1.0 Proposed Changes to Condition 2

1.0 The Proposal

1.0.1 The proposed Minor-Material Amendments comprise internal and external modifications which are summarised in the table below, alongside the reasoning for each of the amendments.

1.1 Amendment Item 1

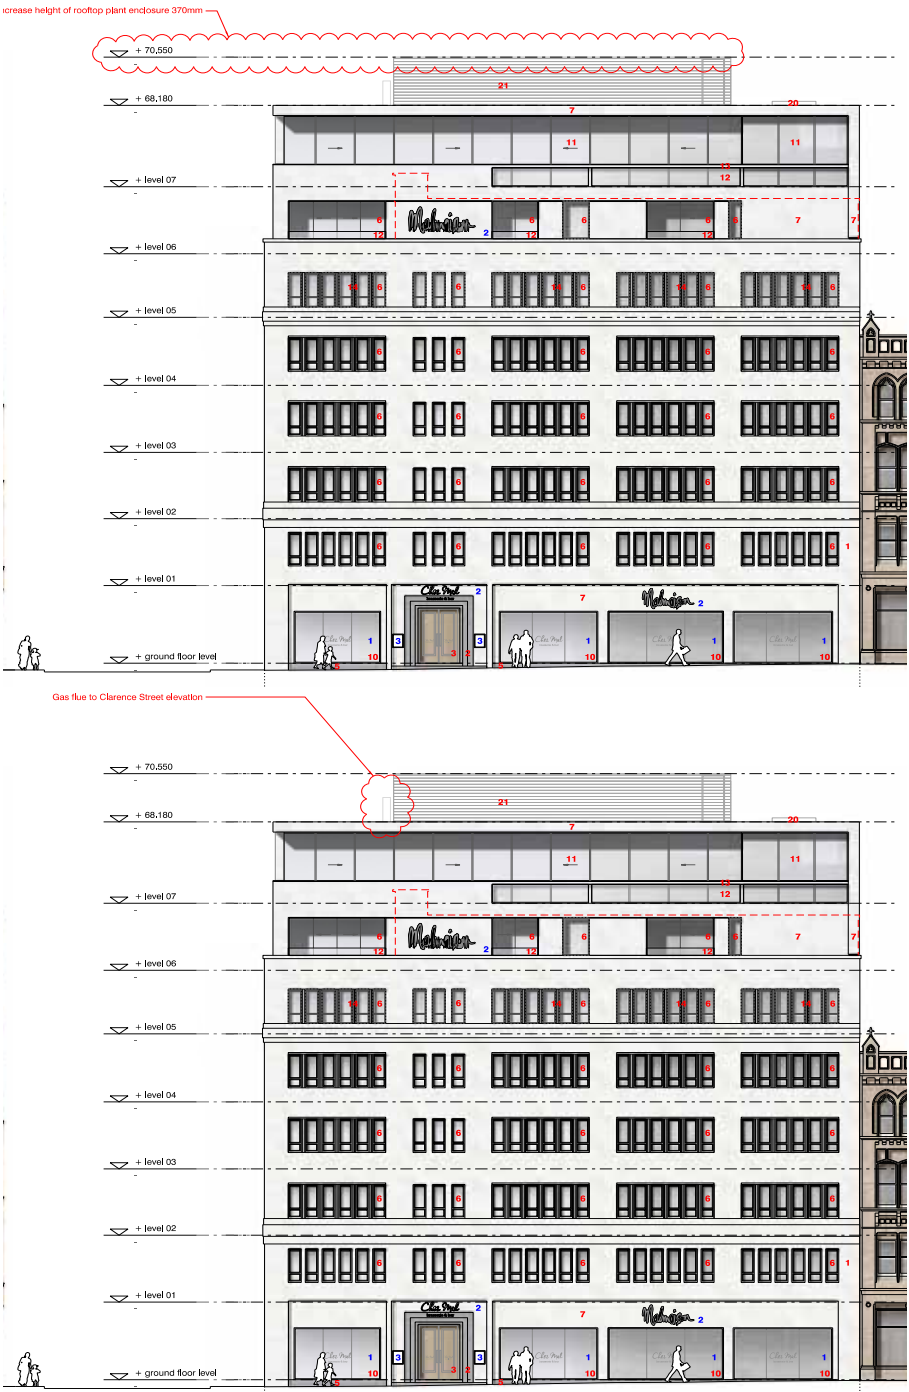
1.1.1 Increase in height of rooftop plantroom louvres.

- 1.1.2 Due to further detailed design develop-ment of the plantroom, the plant has in-creased in height beyond the planning consented drawings. To conceal the plant, the plant screen needs to increase in height by an additional 370mm.
- 1.1.3 The material specification and colour Is as per the consented scheme.
- 1.1.4 The additional height cannot be seen from any of the VIA views.
- 1.1.4 It is considered that this doesn't have a detrimental effect on the architectural appearance of the building.

1.3 Amendment Item 3

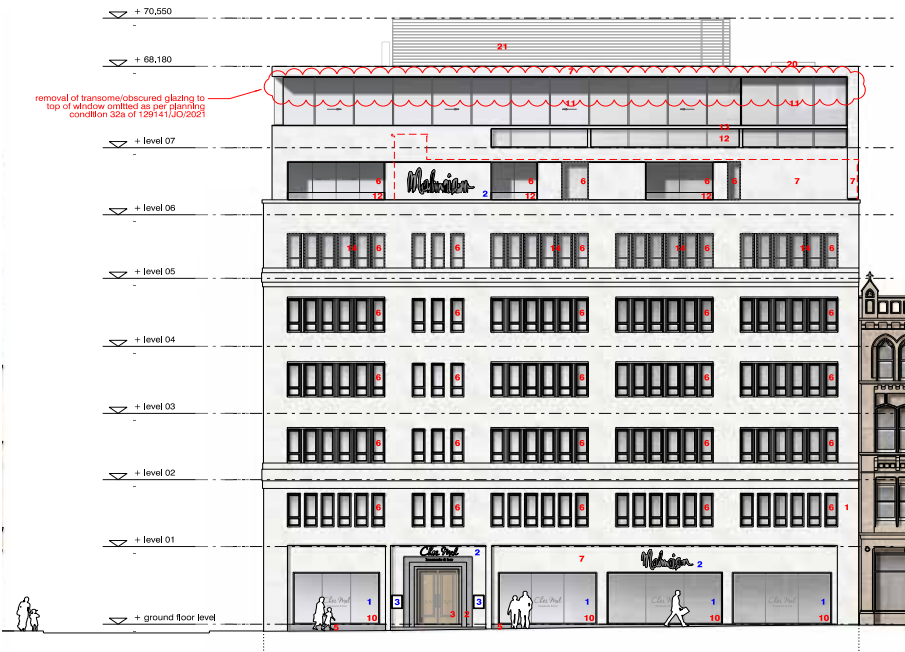
1.3.1 Removal of transoms and obscure glazing to top floor windows. Omitted as per planning condition 32a of application 129141/JO/2021

1.3.2 In accordance with condition 32a of ap-plication 129141/JO/2021, the transoms and obscure glazing have been removed from the design and now reflect the con-sented scheme.

1.4 Amendment Item 4

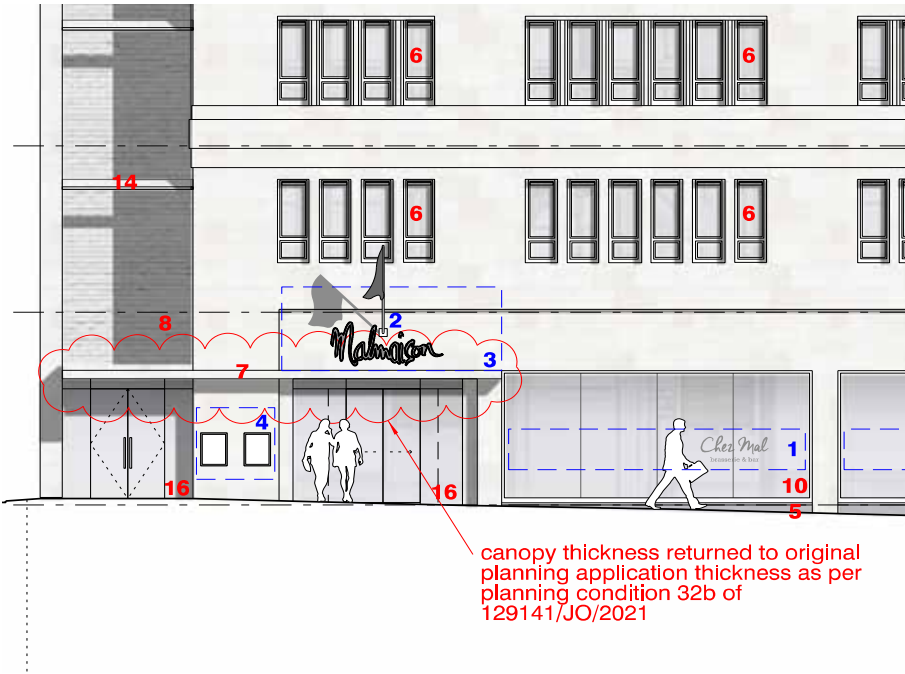
1.4.1 Reduction in canopy thickness to Clarence Street elevation. Reduced as per planning condition 32b of application 129141/JO/2021

1.4.2 In accordance with condition 32b of ap-plication 129141/JO/2021, the canopy has been reduced back to the original design and now reflect the consented scheme

1.5 Amendment Item 5

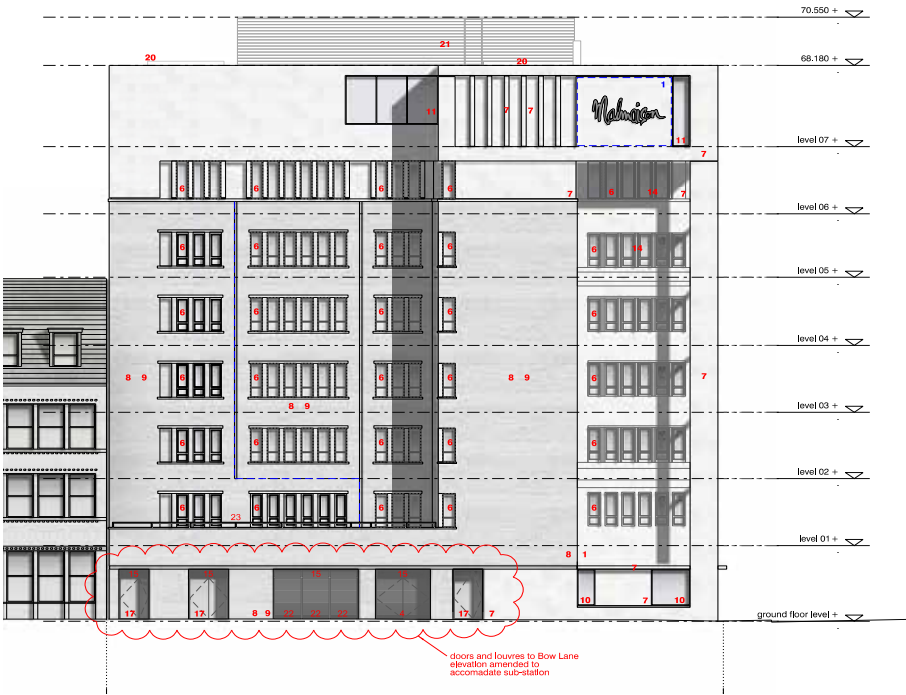
1.5.1 Variation of Bow Lane ground floor elevation to accommodate new substation and ventilation louvres.

- 1.5.2 Due to detailed design development of the Services design, it has been proposed to add a Substation and new ventilation louvres on Bow Lane elevation
- 1.5.3 It is considered that this doesn't have a detrimental effect on the architectural appearance of the building.

1.0 Proposed Changes to Condition 2
Princess Street Elevation Comparison

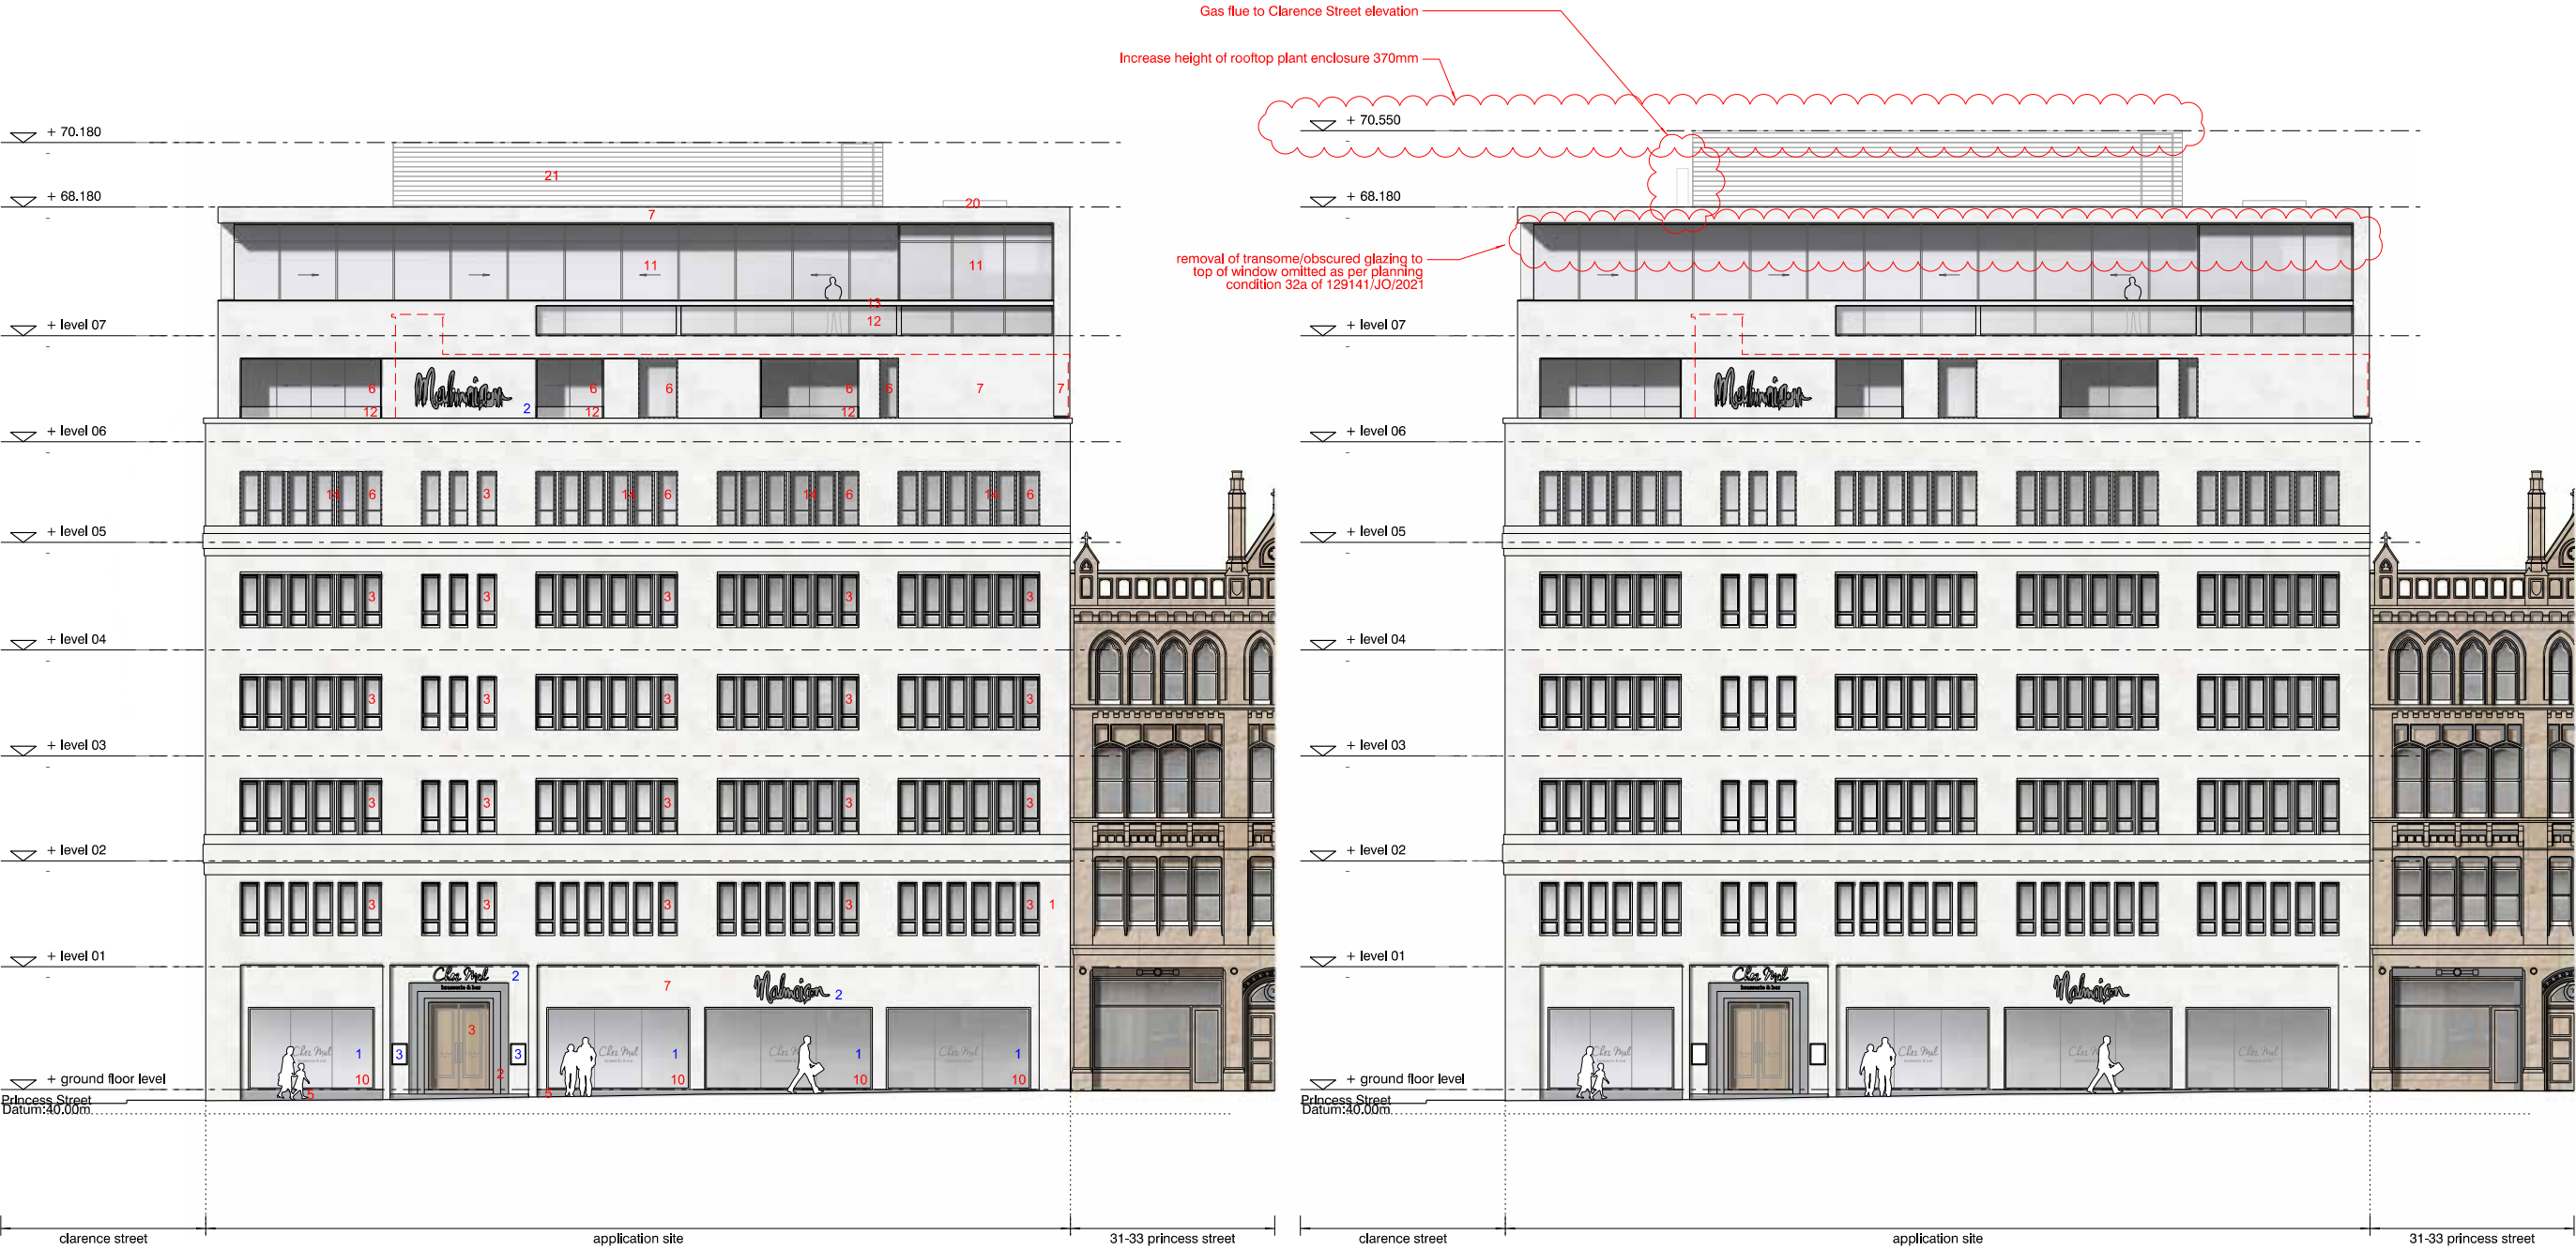
consented scheme - application no:129141/JO/2021

proposed elevation

1.0 Proposed Changes to Condition 2
Clarence Street Elevation Comparison

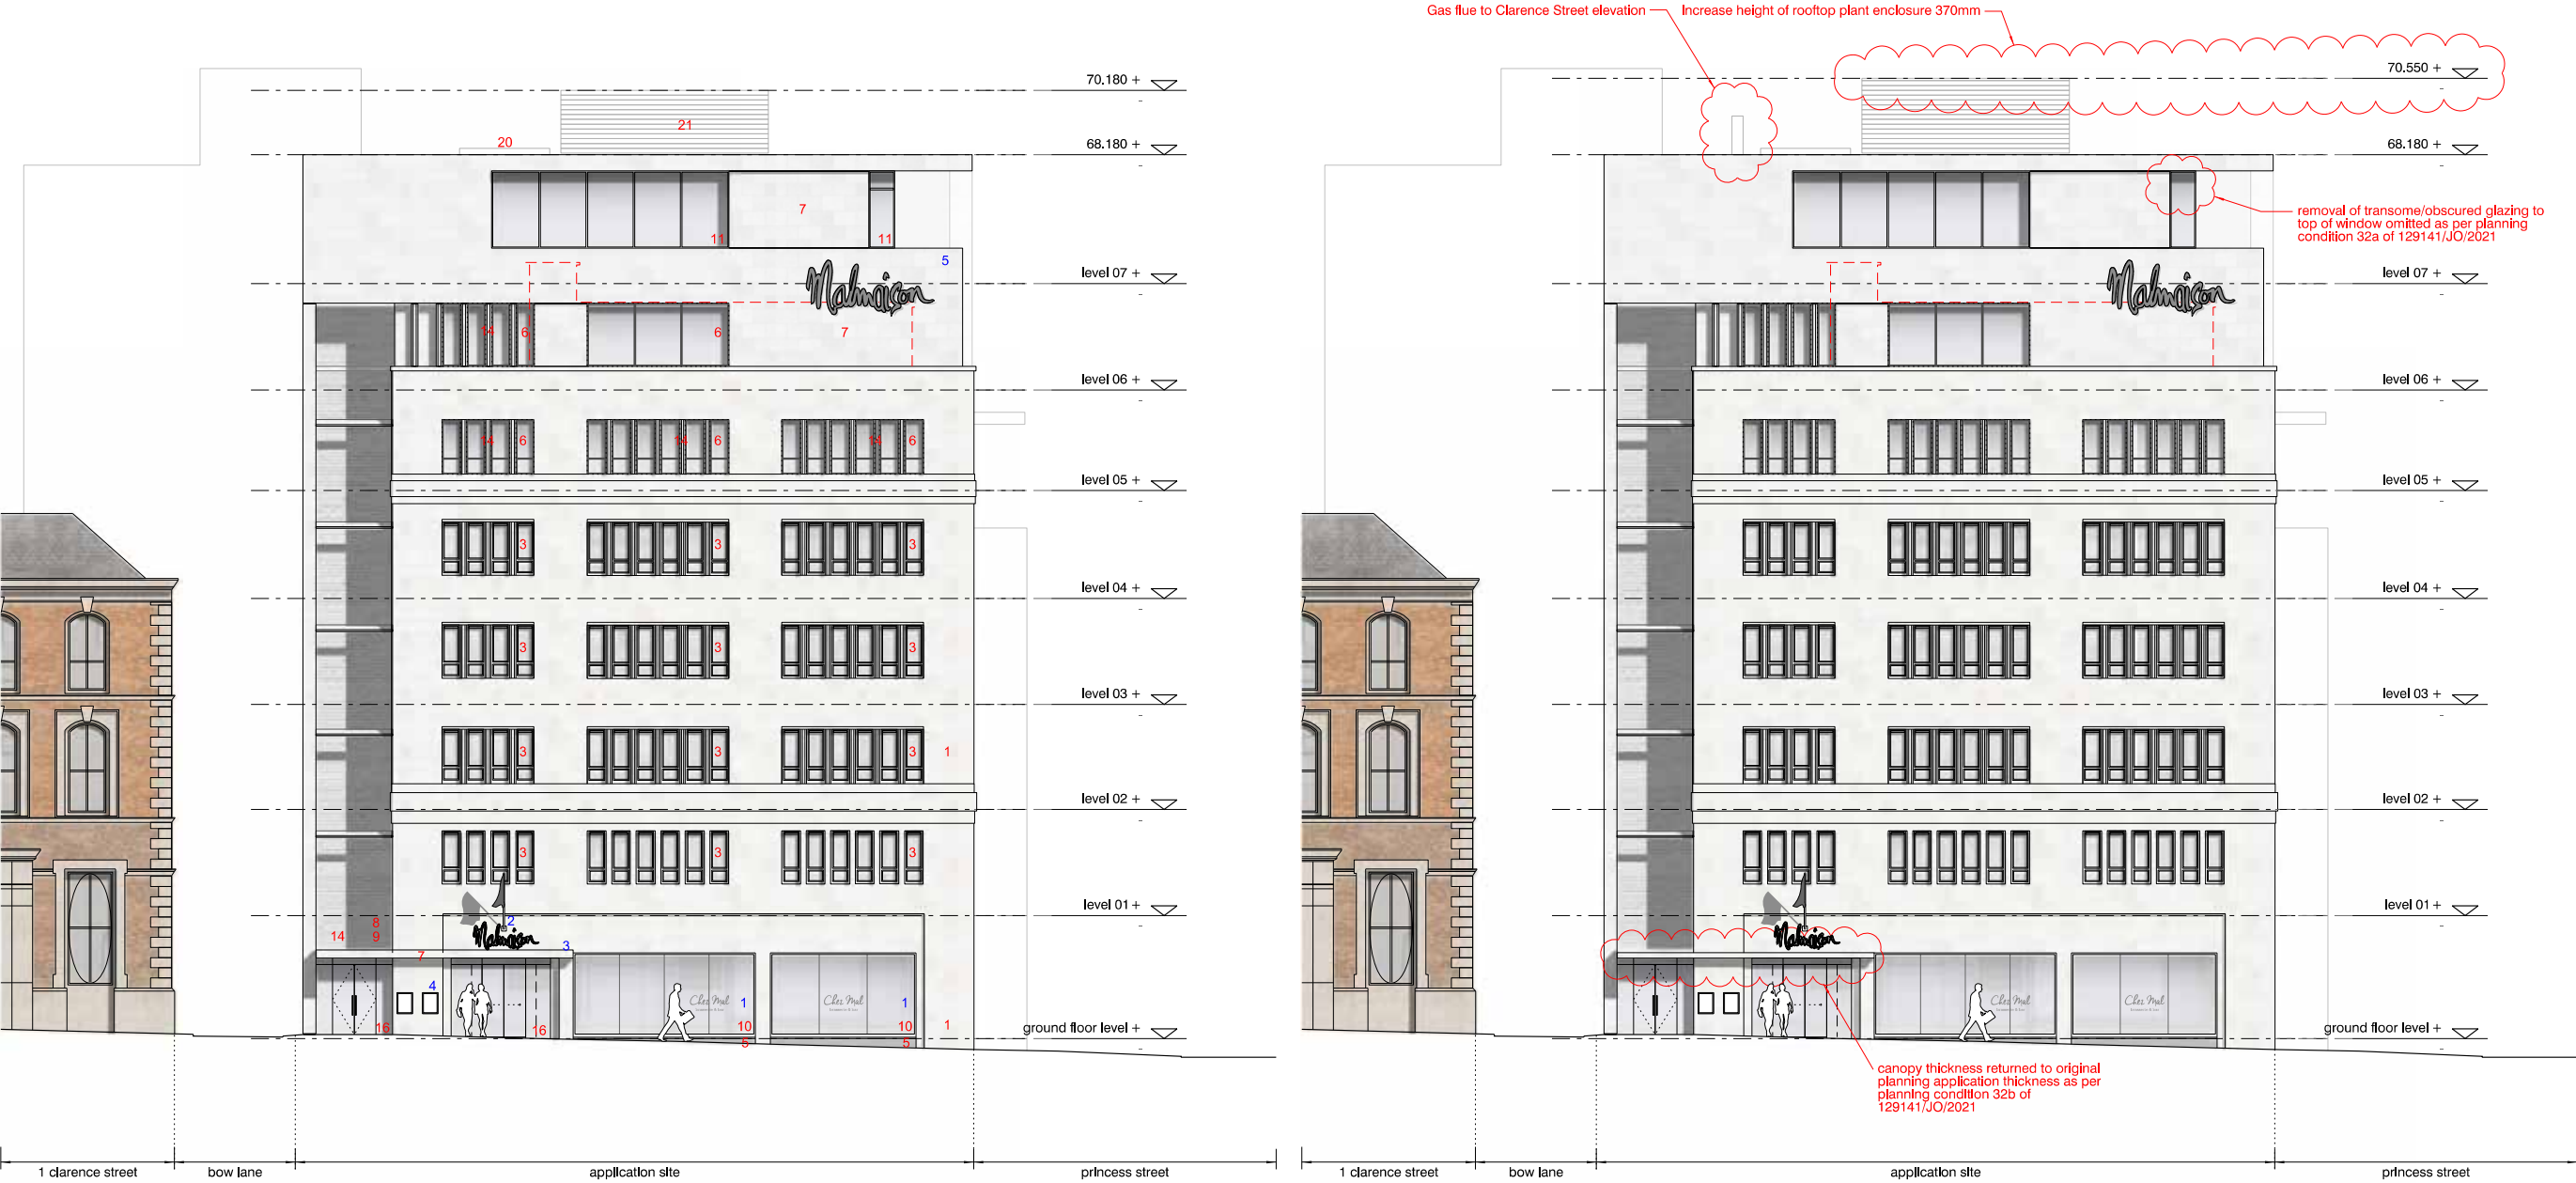
consented scheme - application no:129141/JO/2021

proposed elevation
